PLANNING, ZONING, & BUILDING DEPARTMENT  
PZ&B Staff Combination Memorandum: Architectural Commission and Town Council

SUBJECT: ARC-24-035 (ZON-24-043) 620 N LAKE WAY (COMBO)

MEETING: JULY 24, 2024 ARCOM  
AUGUST 12, 2024 TC

PROPOSED EAST ELEVATION

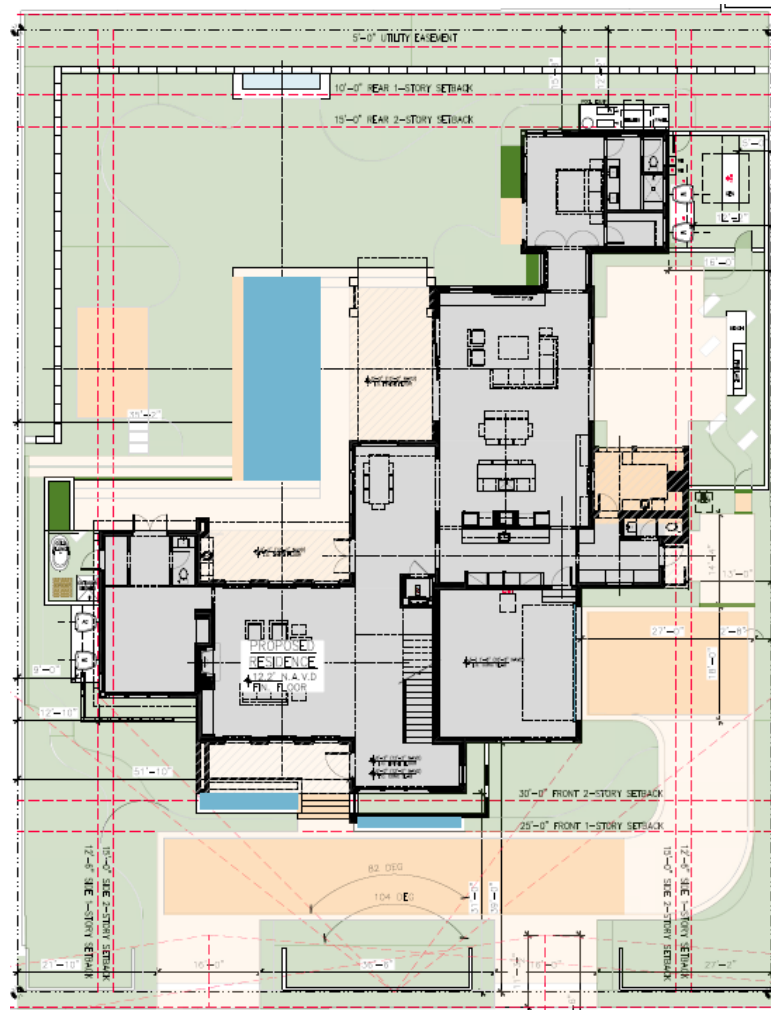
The applicant has resubmitted plans in response to commission comments received at the June ARCOM hearing. The applicant has responded by updating the design of the breezeblock and screening features, reincorporating the vertical window muntin pattern, revising the window and door frame color to a lighter color, and by adding hedge and tree plantings at the front of the property to buffer between the structure and the right of way. The overall building layout, hardscape and landscape configuration remain largely the same from previous review.

EAST PROPERTY LINE ELEVATION (NTS)

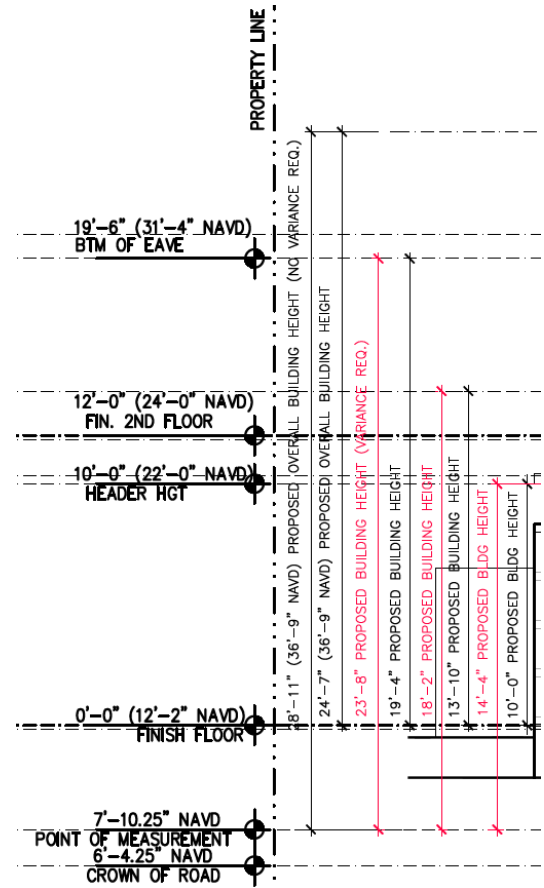
Variance 1 pertains to the proposed building height of the structure. The structure is proposed to be constructed with a building height of 23'8" where a maximum building height of 22'-0" is the maximum building height permitted. Staff will note that this is the height, as taken from the point of measurement, which is *below existing grade*. The applicant is proposing a finished floor elevation of 12.17' NAVD, and if the building height measurement was taken from this point, the building height would be 19'-4" below the 22'-0" maximum permitted.

The definition of building height clearly establishes the point of measurement at 18" above the crown of road, which does not take into account this type of parcel which experiences a somewhat significant change in grade as it traverses from the street on the east side of the parcel to the rear of the lot on the west side of the parcel. The difference in grade from the highest and lowest points on the lot are approximately 7.5'.
